# SOUTH ESSEX PARKING PARTNERSHIP (TRAFFIC REGULATION ORDERS) SUB COMMITTEE

# **AGENDA ITEM 11**

Subject	THE ESSEX COUNTY COUNCIL (CHELMSFORD CITY) (PROHIBITION OF WAITING, LOADING AND STOPPING) AND (ON-STREET PARKING PLACES) (CIVIL ENFORCEMENT AREA) (AMENDMENT NO.29) ORDER 202*
	Relating to Ongar Road, Victoria Road and Back Road Access, Writtle
Report by	South Essex Parking Partnership Manager

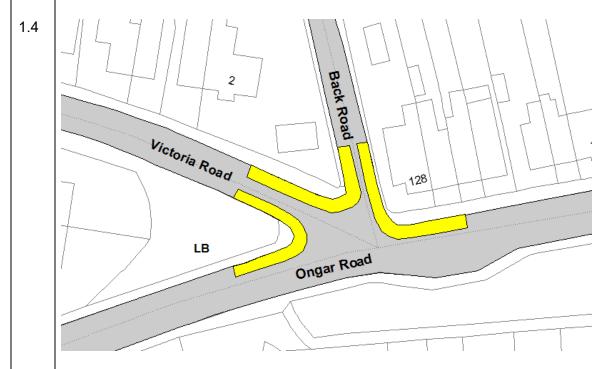
Representations & Responses relating to Ongar Road, Victoria Road and Back Road Access, Writtle			
Ref	Representation	Technician Response		
1.	Dear Sir/Madam	Objection noted.		
	Proposed no waiting on Ongar Road ,Victoria Road and Back Road Writtle I wish to raise an objection to the above planning application on the following grounds.  1. Cost. At a time of council financial problems to spend money on unnecessary road furniture is ridiculous because no one ever parks on the section of Back Road included in the proposal as it is only one car's width.  2. Safety. Ongar Road is already somewhat of a rat run and to clear it of cars by using double yellow lines will encourage more speeding. This applies to Victoria Road as well which at the Ongar Road end is more than three cars wide. There has never been an accident at this junction in forty years. Your measures are likely to change this.  3. Convenience. A lot of the houses here do not have any parking area. These measures will mean people will have to drop off and then move their cars elsewhere increasing traffic and pollution. The bus service is likely to be disrupted more frequently too. It's an unnecessary measure that will make matters worse.	Ongar Road is a busy PR2 route, Victoria Road is a residential road and Back Road is an access road. The bell mouth on Ongar Road is relatively wide, however, the angle that Victoria Road meets it and the addition of Back Road creates an already hazardous junction without the added factor of parked vehicles. There has been 1 recorded accident within the last 3 years between 2 vehicles and a pedestrian which resulted in 1 casualty. During the site visits conducted, it was noted that vehicles parked near or on the junction (including Back Road) causing access/egress problems. The maximum number of vehicles that were noted to be parked on or near the junction was 2. However, the addition of these few cars significantly impacted the safe movement of vehicles.

It is acknowledged that the presence of parked vehicles does have the effect of some traffic calming. However, this scheme has been proposed in line with Rule 243 of the Highway Code which states 'DO **NOT** stop or park... opposite or within 10 metres (32 feet) of a junction'. The SEPP reserves the right to implement a scheme when it is deemed essential. The scheme will be monitored for its effectiveness. It should also be noted that there is no right to park on the highway – the only legal right being to pass and re-pass. It is acknowledged that if the proposal goes ahead, it will limit parking for residents, however, the SEPP has to balance the needs of all highway users while at the same time maintaining the function of the highway network. It is not felt that the introduction of these restrictions will have an impact on the bus network.
